Project Title	Improvements to Public Realm to Bridge Street and lands to the rear and side of The Grain Store, John's Street, New Ross, Co. Wexford
Document Title	Engineering Response to An Coimisiún Pleanála (ACP) Technical Queries
Client	Wexford County Council
File No.	J08_DRPL_020
Author	Peter Brunner
Checked by:	Tom Culligan
Date	29 September 2026
Revision	P1

This report addresses the queries raised by An Coimisiún Pleanála in regard to the proposed improvements to Public Realm to Bridge Street and lands to the rear and side of The Grain Store, John's Street, New Ross, Wexford.

DRAWING: Surface water drainage layout	DRAWING NO: J08-P-10	SCALE: 1:200 @ A1
DATE: June '25	REVISION: P2

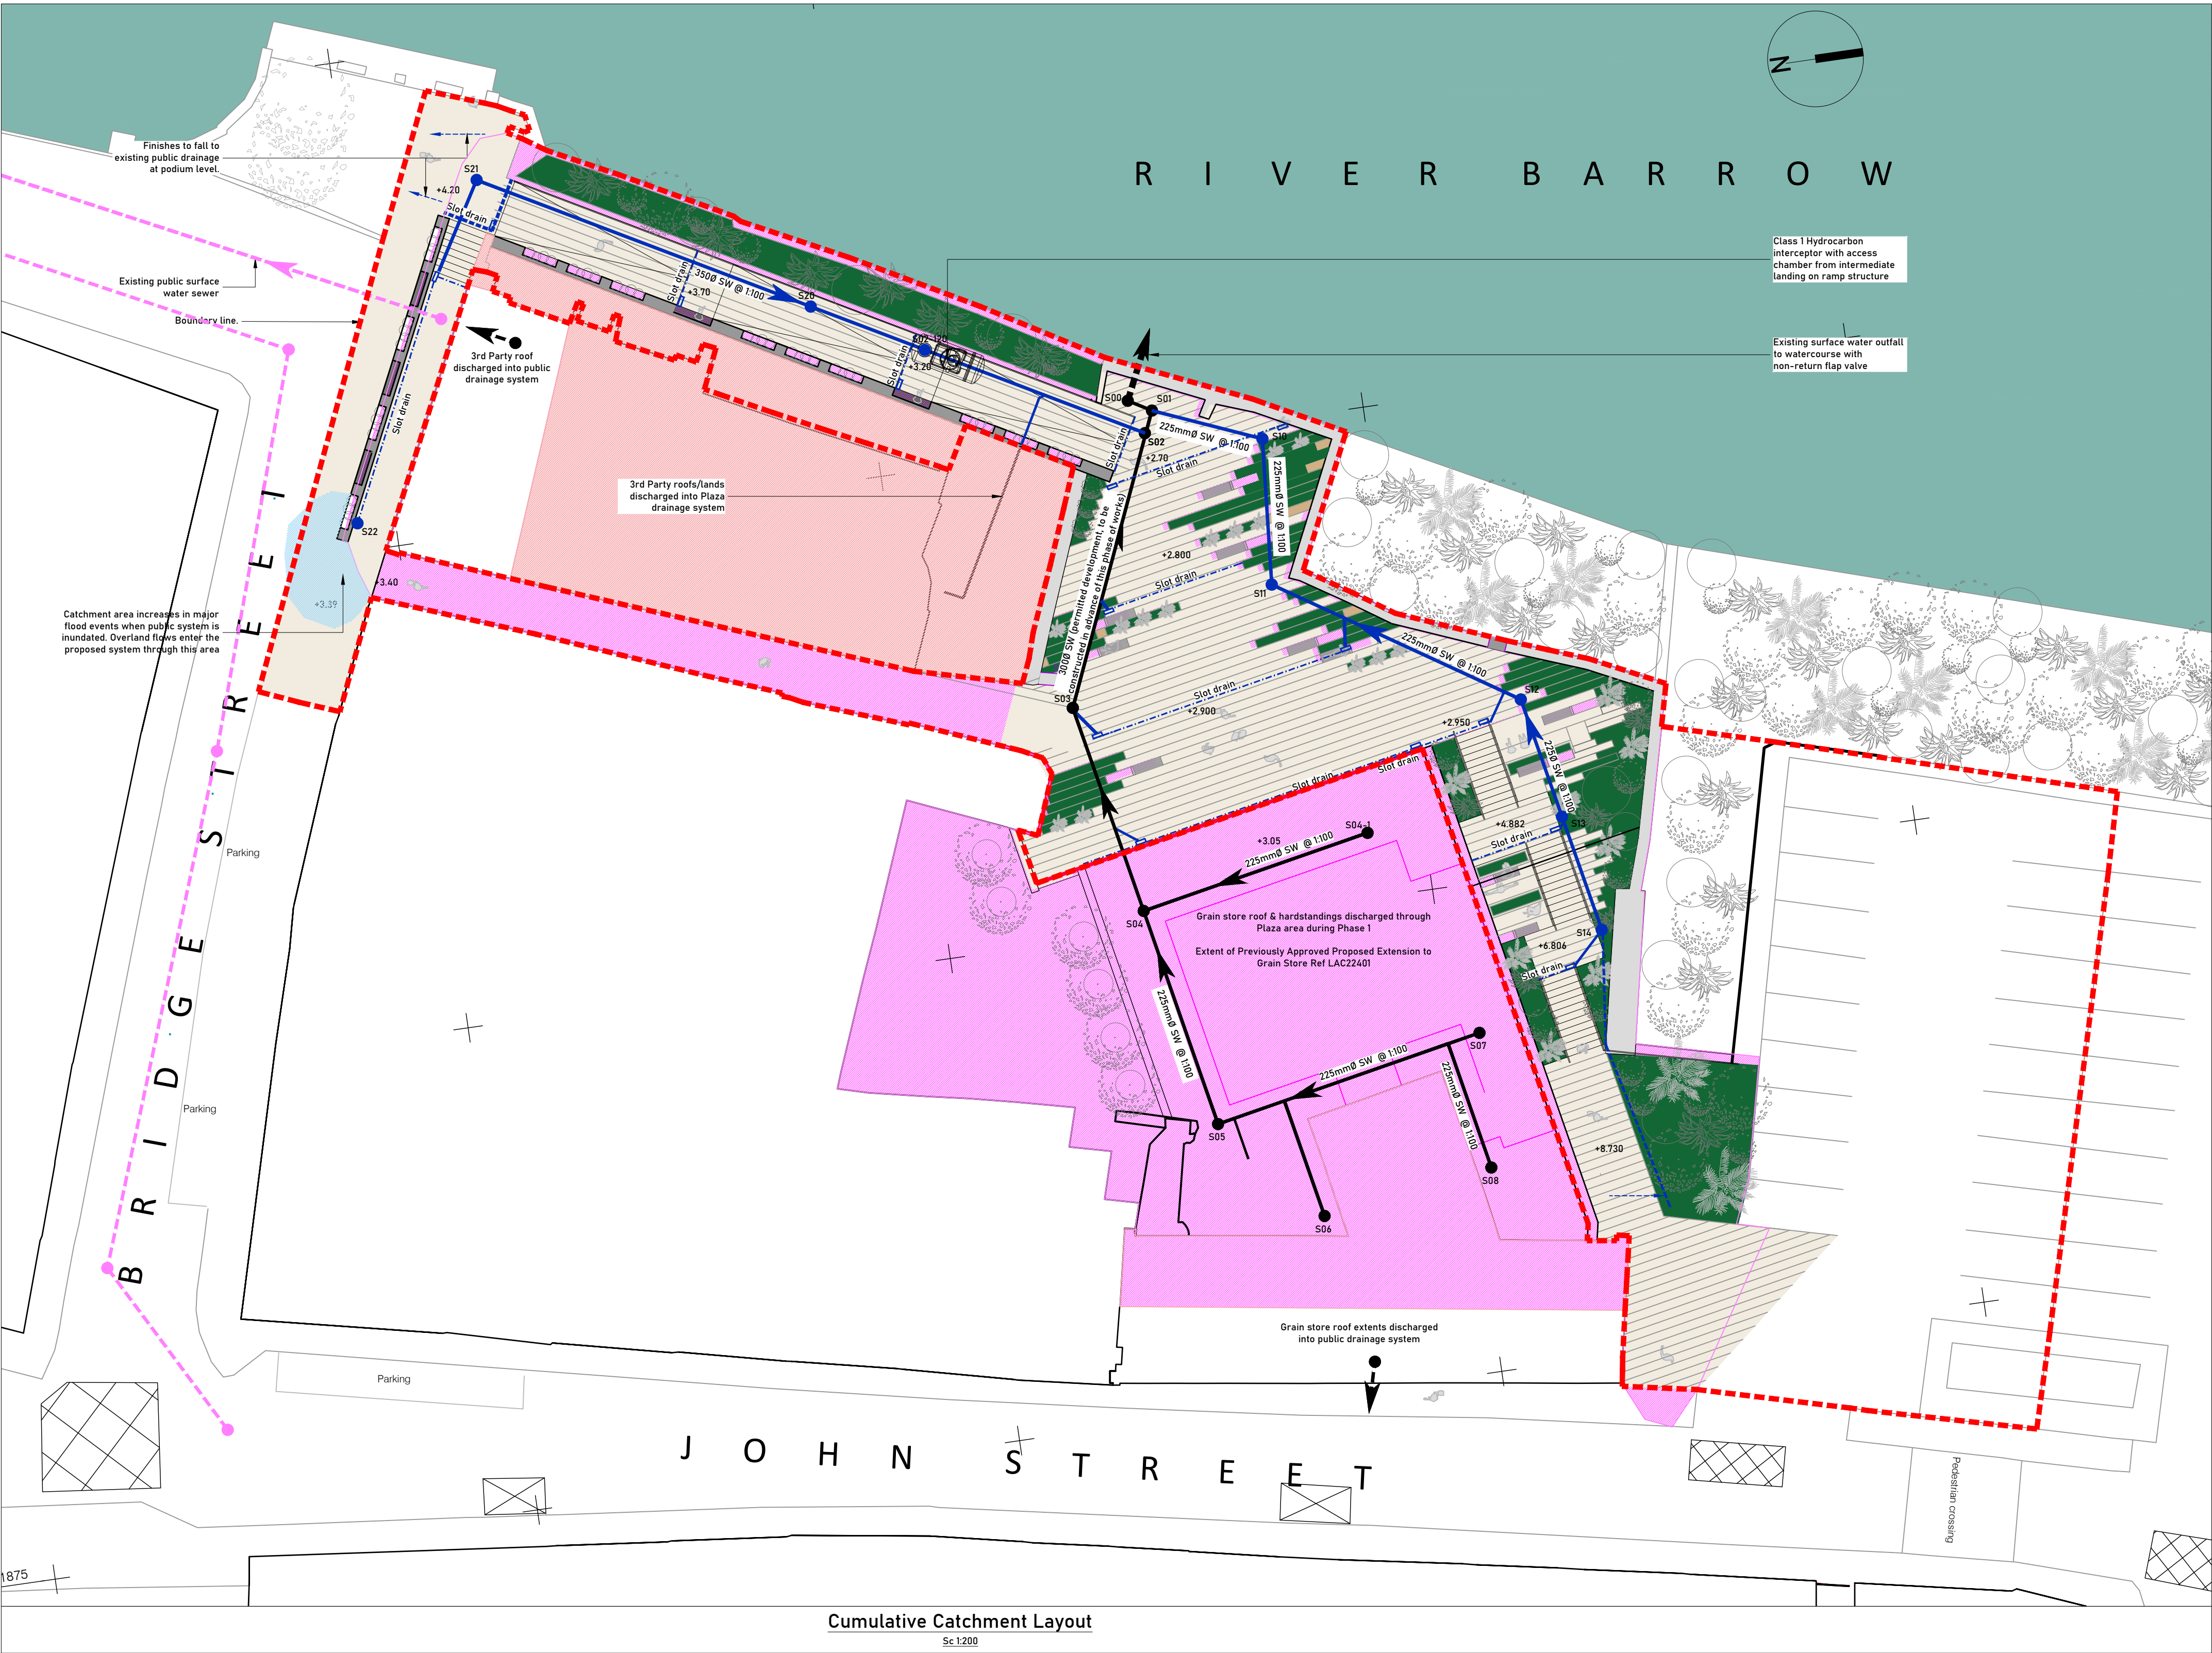
ACP Query: The Board is concerned that the CEMP's proposed mitigation measure to completely block the site's single surface water outfall (S00) to the River Barrow with sandbags during the 18-21 month construction period will cause severe localized flood risk. Specifically, ACP requires details of how surface water will be managed, particularly since both developments share this outfall and may be constructed at different times.

ACP Query: Are there any existing hydrocarbon interceptors on the surface water outfall, or is it proposed to install any on the surface water network prior to surface water entering the River Barrow and River Nore SAC, particularly following flood events that are stated in the Strategic Flood Risk Assessment to be expected to extend inland as far as the café that forms part of the approved Part 8 development?

ACP Query: In relation to the Bridge Street pedestrian access ramp abutting No. 2 Bridge Street (Rogers Dental), ACP requires an existing surface water drainage plan, details of any pipes/manholes to be retained or removed, and precise engineering details on how any existing manholes beneath the proposed ramp will remain accessible for maintenance without requiring structural demolition of the ramp.

Because Phase 1 (Grain Store) will be operational prior to the commencement of Phase 2 (Plaza) works, the main 300mm surface water collection line (S03 to S00) must remain fully live and unblocked to drain the active Phase 1 building and café roof. To completely isolate the Phase 2 plaza construction yard without impacting the live Phase 1 drainage, we specify a Dynamic Branch Isolation Protocol:

- *Localized Tributary Plugging:* The contractor shall not place sandbags or blocks inside the main outfall S00. Instead, localized mechanical inflatable pipe stoppers shall be installed in the tributary inlets of the Plaza network, specifically at Manhole S10 (blocking incoming S11/S12) and Manhole S20 / S22.
- *Separation of Active Runoff:* This physically blocks the construction-phase plaza runoff from entering the shared sewer line, keeping cement wash, sediment, and hydrocarbons entirely localized to the excavation trenches.
- *Active Treatment & Pumping:* Silt-laden trench water will be actively pumped using submersible pumps to a mobile, on-site silt-filtration and pH-neutralization system (e.g., Siltbuster) located on site before being discharged as clean effluent back into the live S01 outfall chamber.

While the proposed Public Realm Plaza is entirely pedestrianized and incorporates extensive SuDS filtration greening that negates the chronic operational risk of on-site vehicular oil leaks, we have included a permanent Class 1 Bypass Hydrocarbon Separator on the final collector outfall line. The Hydrocarbon Separator includes 2,000litre silt trap storage capacity.

- **Bridge Street Overland Runoff Capture:** Existing public utility surveys and levels indicate that Bridge Street (which remains an active public road with significant vehicle traffic) slopes down toward the site boundary. During heavy rain events, substantial volumes of overland stormwater runoff from outside the site boundary collect at the low points along Bridge Street.

- **S22 and Linear Drain Vulnerability:** The existing public surface water connection manhole S22 and the adjacent linear slot drain are located precisely at these road low point. Consequently, potentially contaminated surface runoff from the public highway (containing road-derived hydrocarbons, fuels etc) may enter the proposed surface water system during heavy storm events.

- **Class 1 Bypass Separator Specification:** To robustly protect the adjacent River Barrow and River Nore SAC, BCE has specified a permanent Class 1 Bypass Hydrocarbon Separator (conforming to EN 858 and CIRIA C753 standards) to be installed on the main outfall collector line just upstream of outfall chamber S02. This unit is designed to treat flows up to 90% of the peak runoff, ensuring that all road-derived hydrocarbons are fully separated and retained on-site, even during catastrophic storm or tidal back-flooding events.

- **Non-Destructive Maintenance Access (S20, S21, S22):** The proposed ramp alignment directly overlies BCE manholes S20, S21, and S22. To ensure Wexford County Council maintenance crews can access these structures at all times without structural demolition or ramp closure, ODKM Architects will integrate flush-mounted, removable structural floor access panels directly into the ramp's timber/composite perforated decking. These lightweight, slip-resistant composite panels can be easily lifted to expose the underlying standard manhole covers for routine rodding, jetting, or CCTV surveys.

DRAWING:	Cumulative Catchment Map	DRAWING No:	J08-P-11	SCALE:	1:200 @ A1
DATE:	August '26	REVISION:	P2

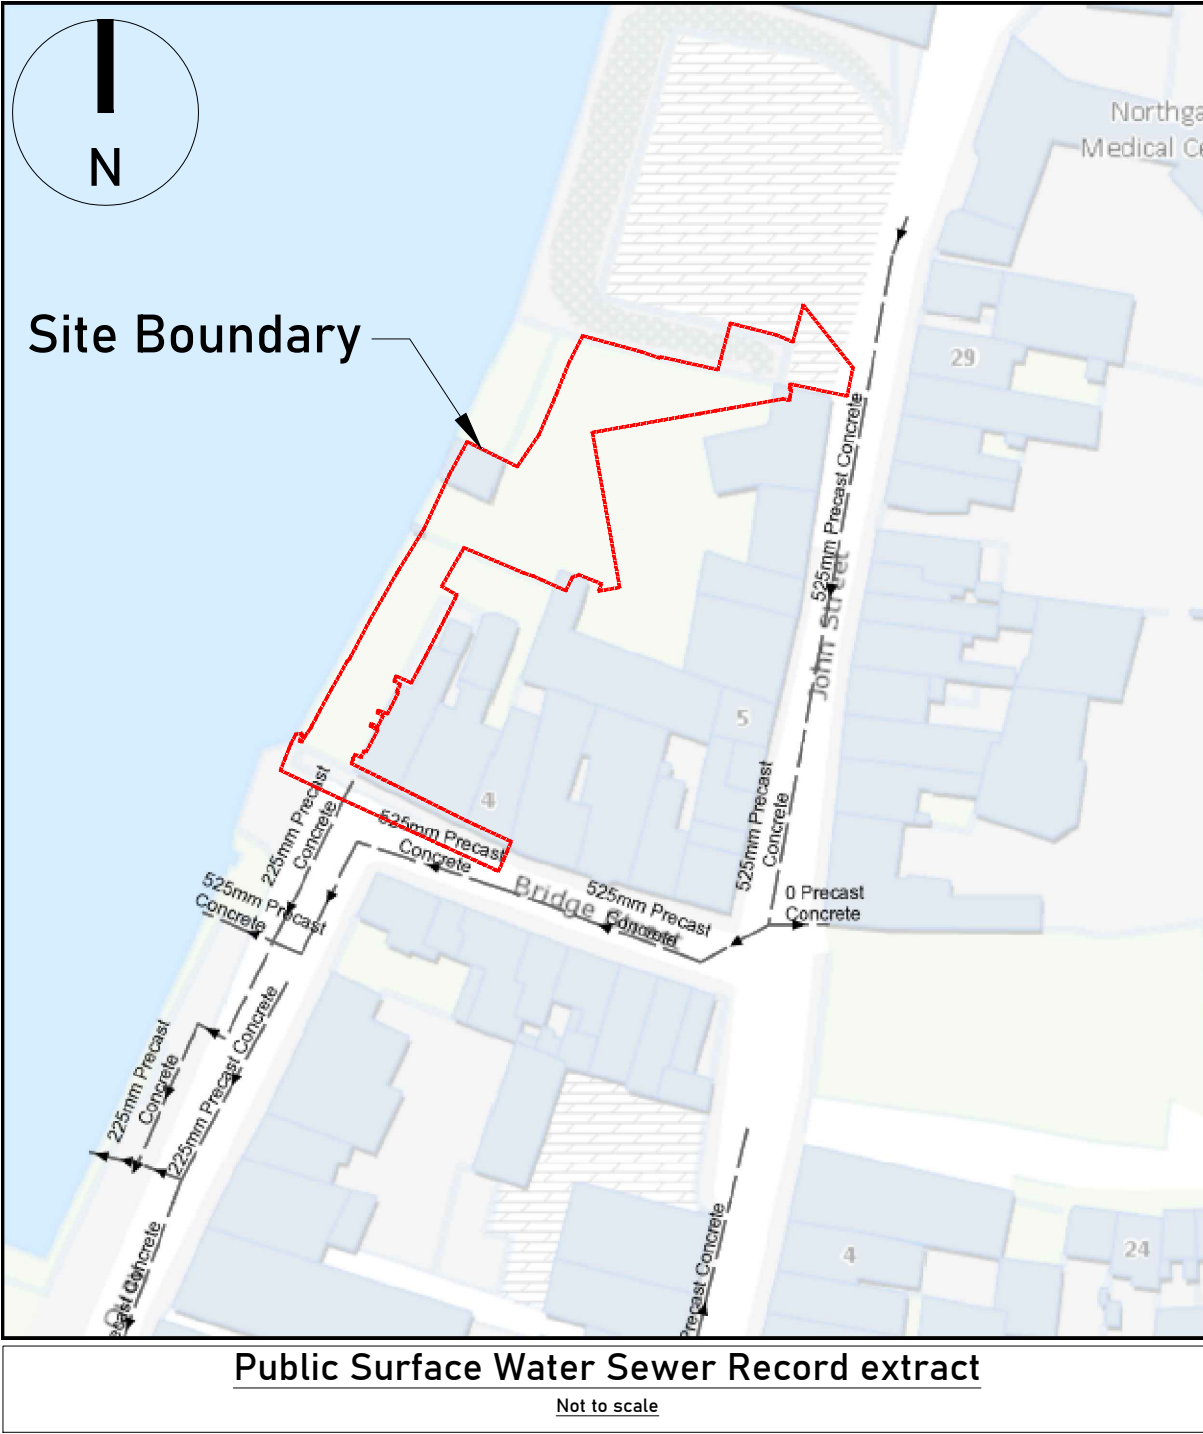
ACP Query: The Board notes that the drainage reports evaluate the plaza and building in isolation. ACP requires cumulative drainage calculations to demonstrate that combined surface water runoff from both developments is less than or equal to current discharge, alongside a combined catchment map.

The baseline site is currently 100% impermeable, generating high, unattenuated peak runoff directly into the River Barrow via gravity outfall S00. Our cumulative design integrates dual-stage Sustainable Urban Drainage Systems (SuDS) across both consecutive phases to significantly reduce the net impermeable catchment area:

The main 300mmØ outfall sewer running from S01 to outfall S00 at a 1:100 gradient has a full-bore hydraulic capacity of 78.4 l/s. Under the cumulative 1-in-100-year storm event (incorporating a 20% climate change surcharge), the combined peak flow from both developments is 21.2 l/s, which represents a 23.5% net reduction in discharge against the baseline and utilizes less than 30% of the pipe's capacity. Drawing J08-P-11 (Cumulative Catchment Map) to formally demonstrate this performance.
